**SUSQUEHANNA STEAM ELECTRIC STATION  
PROPOSED LICENSE AMENDMENT NO. 285  
FOR UNIT 1 OPERATING LICENSE NO. NPF-14  
AND PROPOSED LICENSE AMENDMENT NO. 253  
FOR UNIT 2 OPERATING LICENSE NO. NPF-22  
EXTENDED POWER UPDATE APPLICATION  
REGARDING STEAM DRYER AND FLOW EFFECTS  
REQUEST FOR ADDITIONAL INFORMATION  
RESPONSES  
PLA-6176**

**Docket Nos. 50-387  
and 50-388**

**Attachment 2**  
**Non-Proprietary Version of the Request for**  
**Additional Information Responses**

**Figure 9-5 - Pressure data collected on main steam line C (upper location) at Susquehanna (converted from strain gage data), prior to application of coherence to reduce noise. Top: A typical time segment from 30 to 40 seconds is shown; bottom: the PSD.**

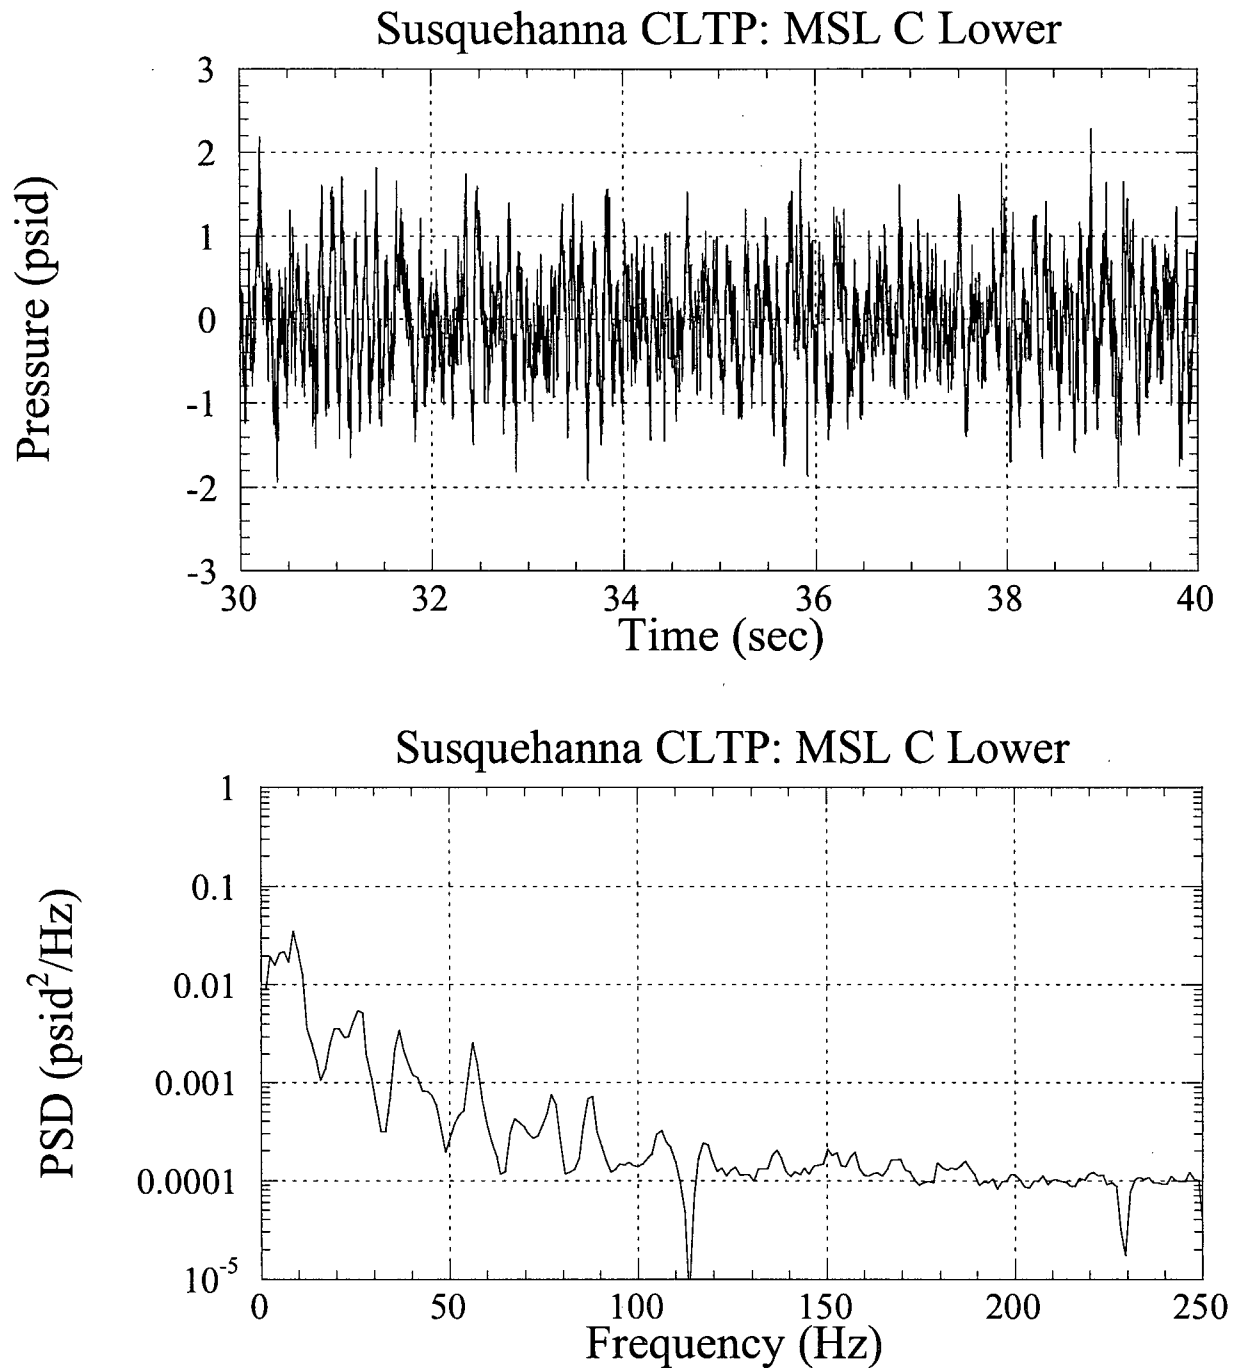
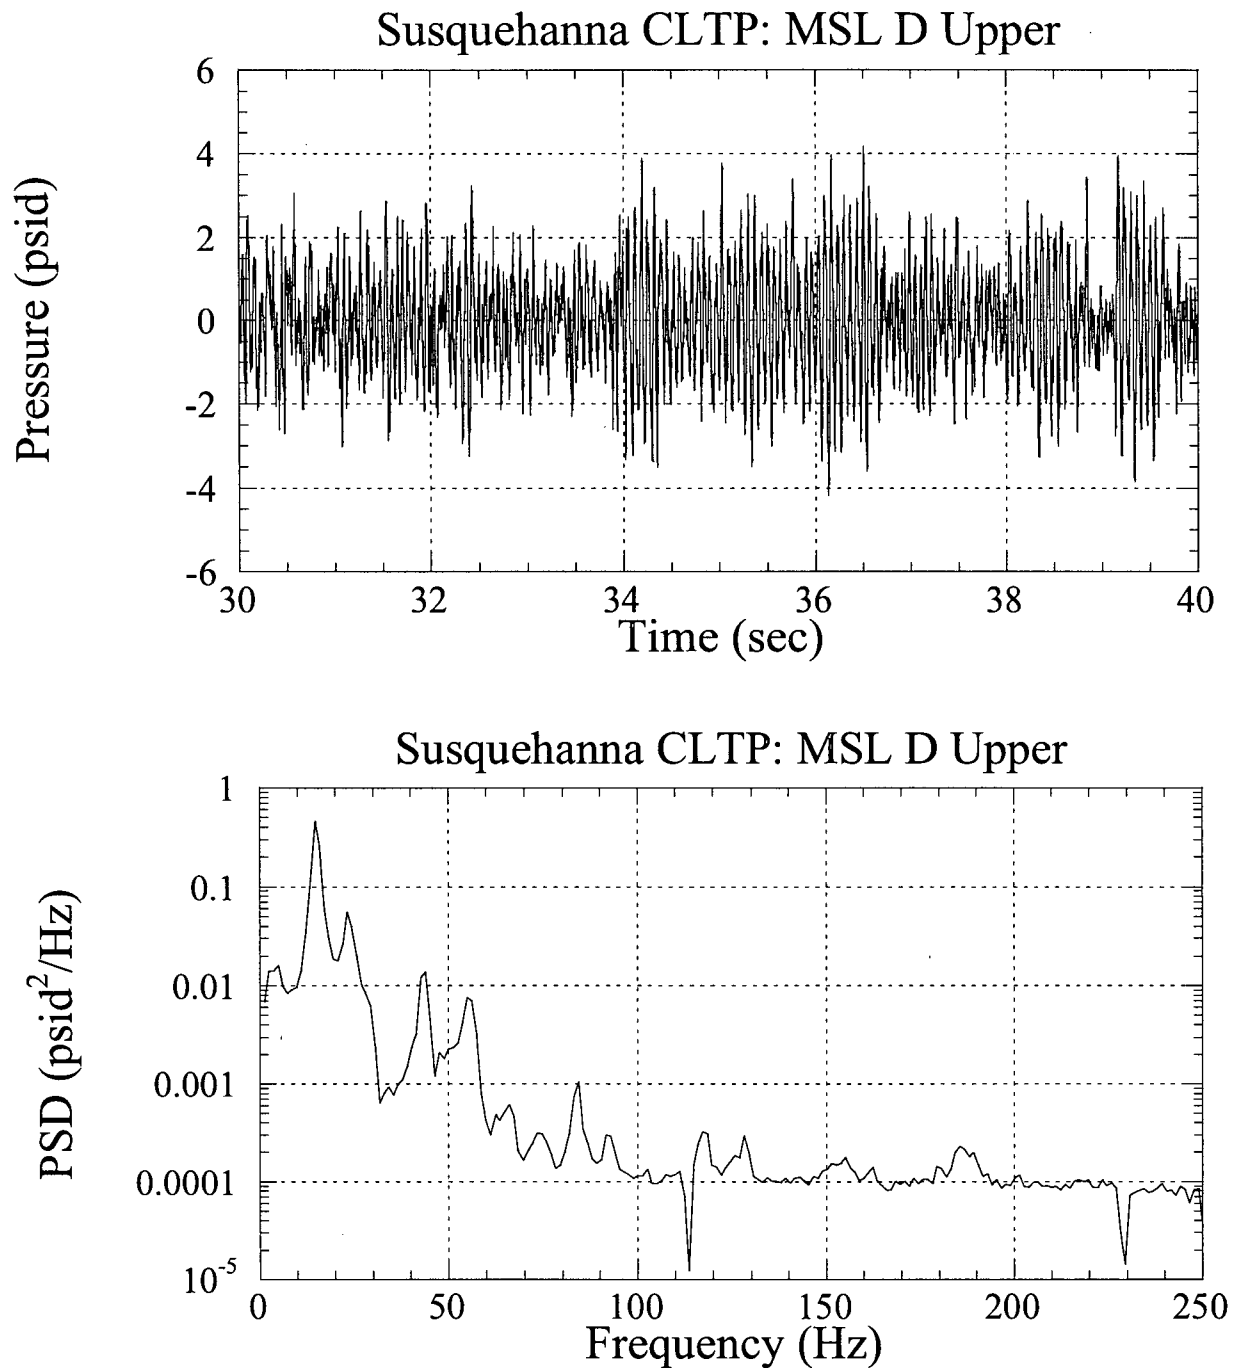
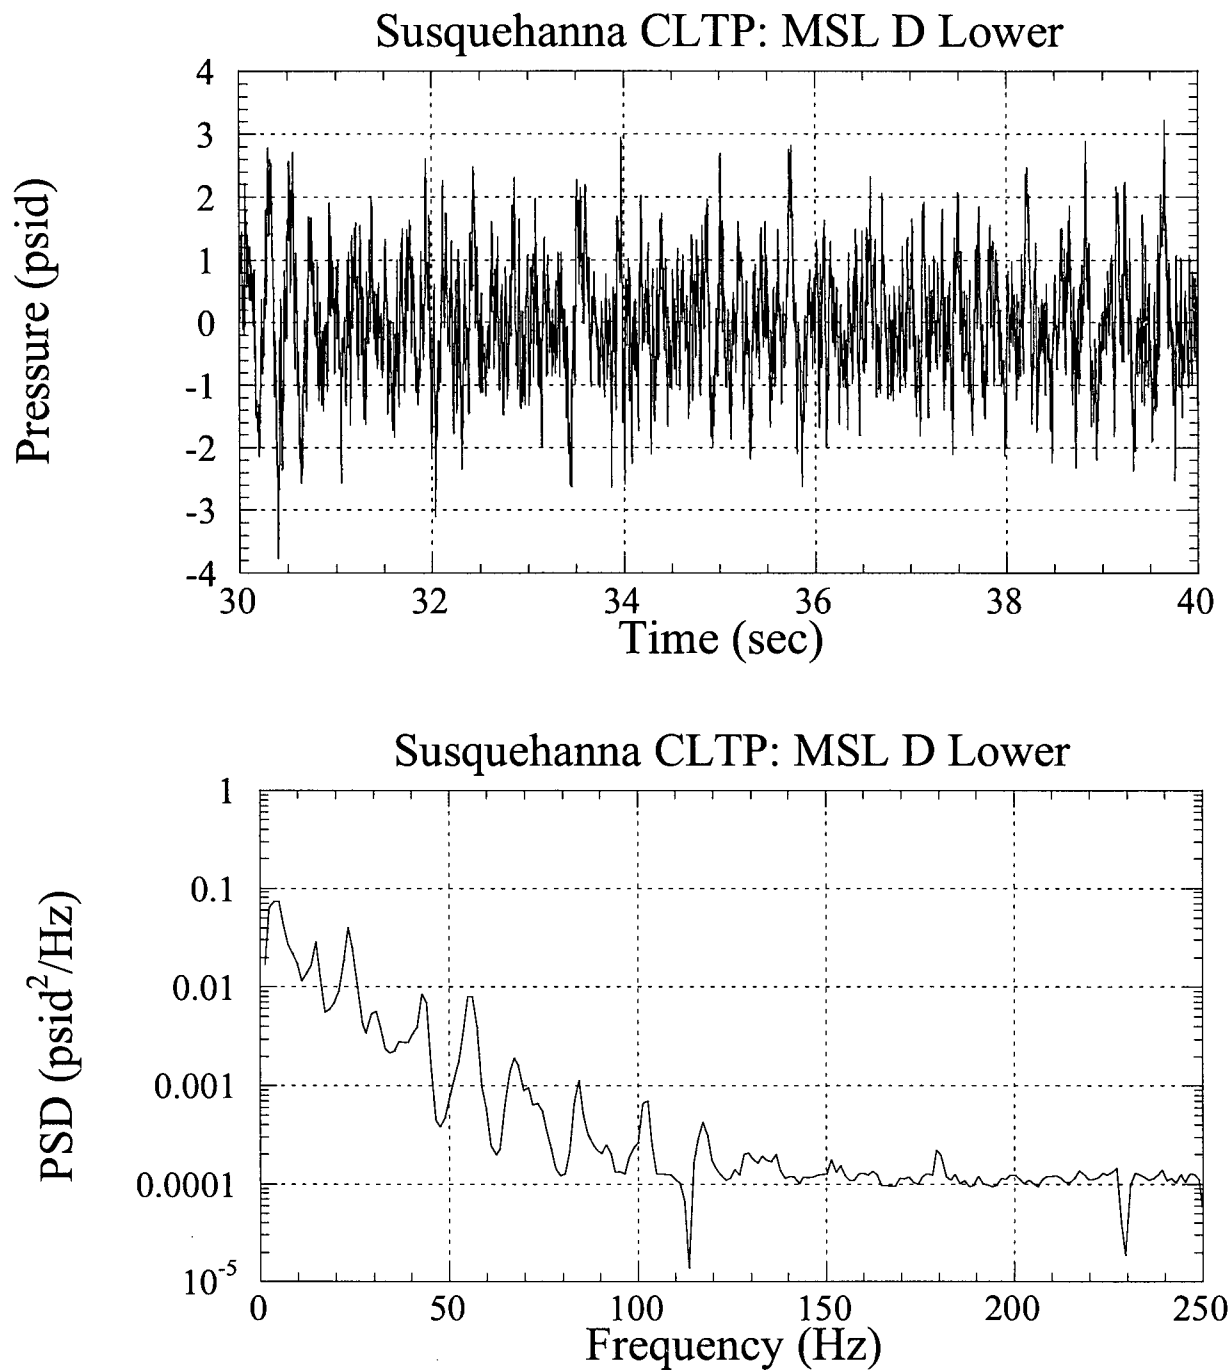
With regard to CDI 06-22, the licensee is requested to provide samples of unfiltered strain gage time signals and power spectral densities. In particular, the provided samples should include the worst case of signal to noise ratio and any other signals experiencing saturation problems or poor frequency response.

The attached Figures 9-1 through 9-8 provide the unfiltered pressure time histories and PSDs at CLTP conditions.

**Figure 12-1 - Pressure data collected on main steam line D (upper location) at Susquehanna (converted from strain gage data), prior to application of coherence with main steam line D (lower location) to reduce noise (top) and after application of coherence (bottom).**

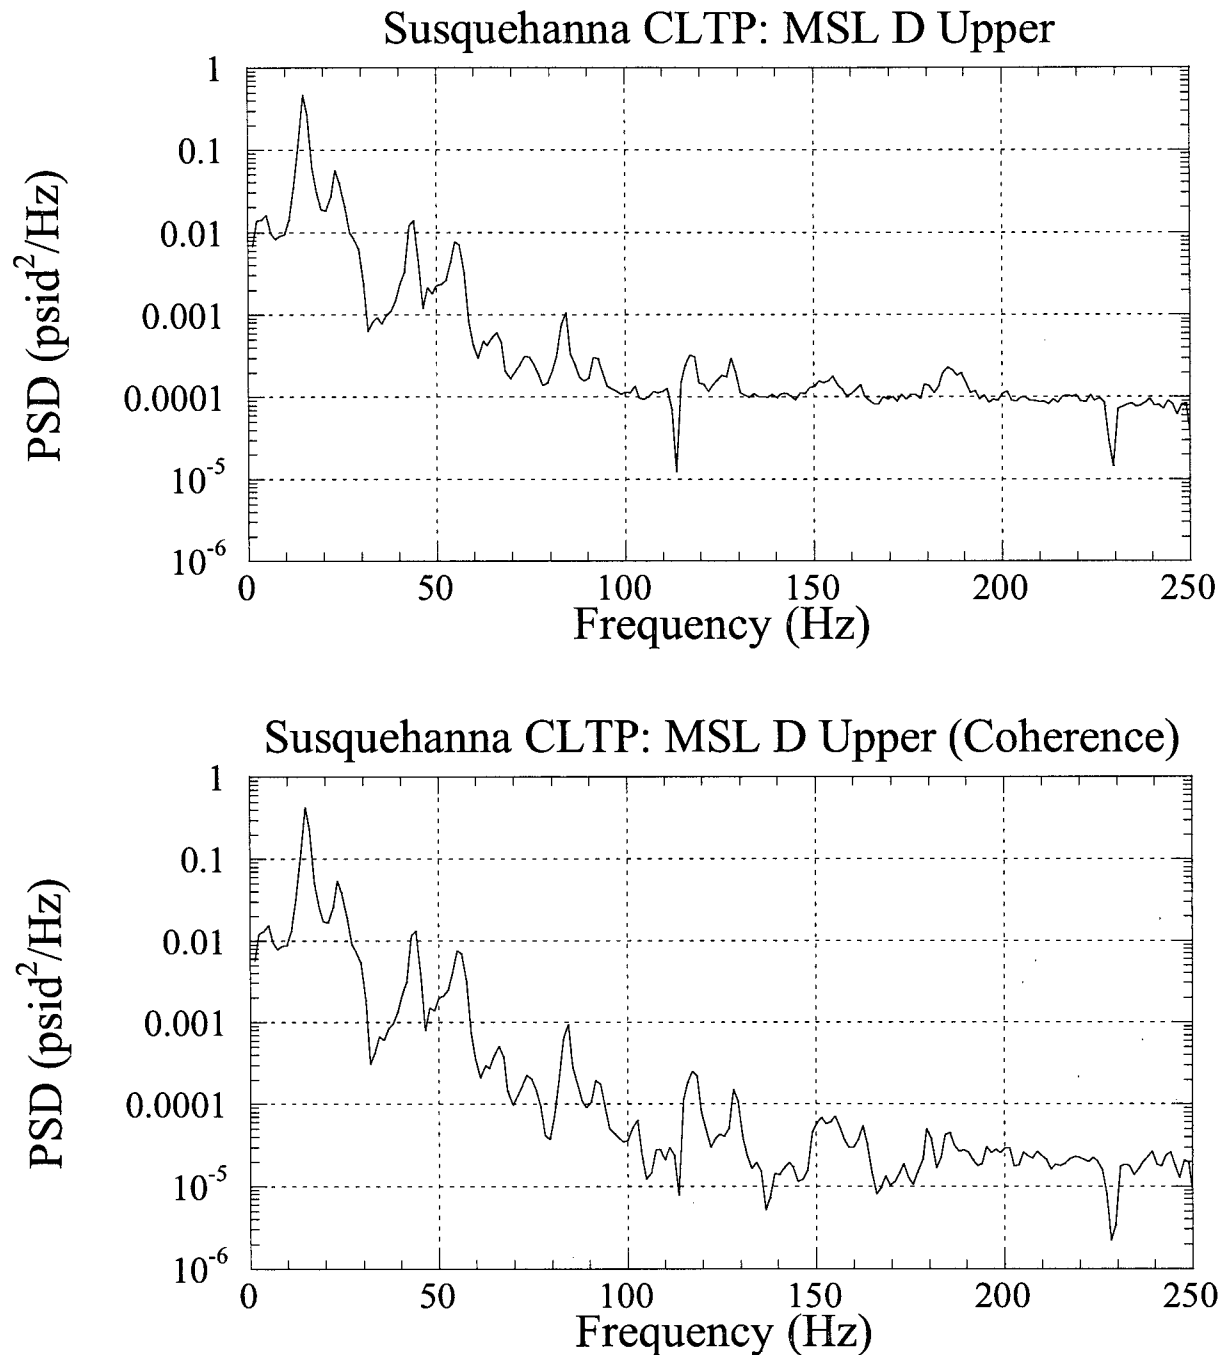
With regard to CDI 06-22, the licensee is requested to provide an assessment of the effect of the MSL strain gage noise reduction on the hydrodynamic part of the ACM predicted load on the dryer.

The attached Figure 12-1 provides a comparison between the upstream pressure signal on MSL D before and after applying coherence with the downstream pressure signal to reduce noise.
